Re: Structural Observation — 30 Albert Court, Sanford, NC 27332

At your request, on December 1, 2023 we performed a review of the structural plan proposed by *Tarheel Basement Systems* for the foundation and 1st floor framing replacement work at the Sanford residence noted above. The structure is a conventionally framed, detached, single family residence with raised first floor framing over a pier/girder foundation system with perimeter masonry foundation walls (see picture 1).

REPAIR SCHEMATIC 9CALE: N.T.S.

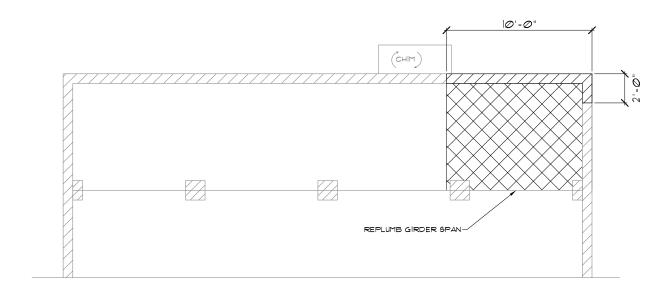
- A vehicle was reported to have impacted the back-right of the home. The following damages to the foundation and 1st floor framing were noted through investigation from the crawlspace (see pictures 2-4).
 - Along the back of the home, the rightmost 10' of the foundation.
 - The joists and rim along this portion of the foundation were damaged beyond salvable repair. The rightmost 12' of the sill plate was damaged beyond repair or had rotated.
 - Along the right of the home, the backmost 2' of the foundation.
 - The right most span of the backmost girder had rotated.

- 1) Remove damaged portions of the foundation wall for installation of a conventional 8" wide foundation wall with 8" solid cap block.
 - a) The existing footing is likely in good condition. Excavate the soils for inspection of the footing. The existing footing may be reused if it has not rotated or broken. If the footing has been damaged, it should be replaced with a new footing matching the dimensions of the existing.
 - i) If applicable, dowel the new footing into the existing footing using (2) horizontal #4 bars x 24" long at the footing mid-depth. Drill 6" into the existing and epoxy using Simpson "Set-3G" or similar epoxy installed per manufacturer specifications.
 - b) Install a new full height 2x rim that bears over a treated 2x sill plate anchored to the wall with ½" diameter bolts with 7" embedment into the top course of the

wall, at 6'-0" on center spacing and 12" max / 5" min from plate ends and breaks.

- i) Alternatively, Simpson "Flat Retrofit Foundation Plates" may be used in lieu of ½" diameter bolts.
- 2) Reinforce each of the joists in the back bay where the foundation is being replaced with an additional full depth ply of 2x #2 Southern Yellow Pine (SYP), fastened to the side of the existing using (3)10d common nails at each end and at 12" on center staggered top and bottom along the lengths of the joists. Sistered material should span continuously between end supports.

- a) Verify all floor sheathing edges are properly supported by floor framing. Joists may be removed and replaced entirely with matching materials if necessary. If so, fasten sheathing of matching thickness to the new floor framing using 8d common nails at 6" o.c. at panel boundaries, and 12" o.c. to joists within the panel field. Splice panels over centerlines of joists as needed with 1/8" minimum edge nail distance. No section of sheathing should be smaller than 2'-0" in any direction.

- 3) Replumb the above noted rotated girder.
- 4) Any additional cracks in perimeter masonry walls that are not specified to be replaced should be closed with a clear or color-matching flexible sealant and should be monitored for signs of further movement.

NEW 8" FOUNDATION WALL W/8" SOLID CAP PER REPORT, REPLACE RIM AND SILL PER REPORT ALONG REPLACED FOUNDATION WALL

AREA TO REINFORCE FLOOR JOISTS
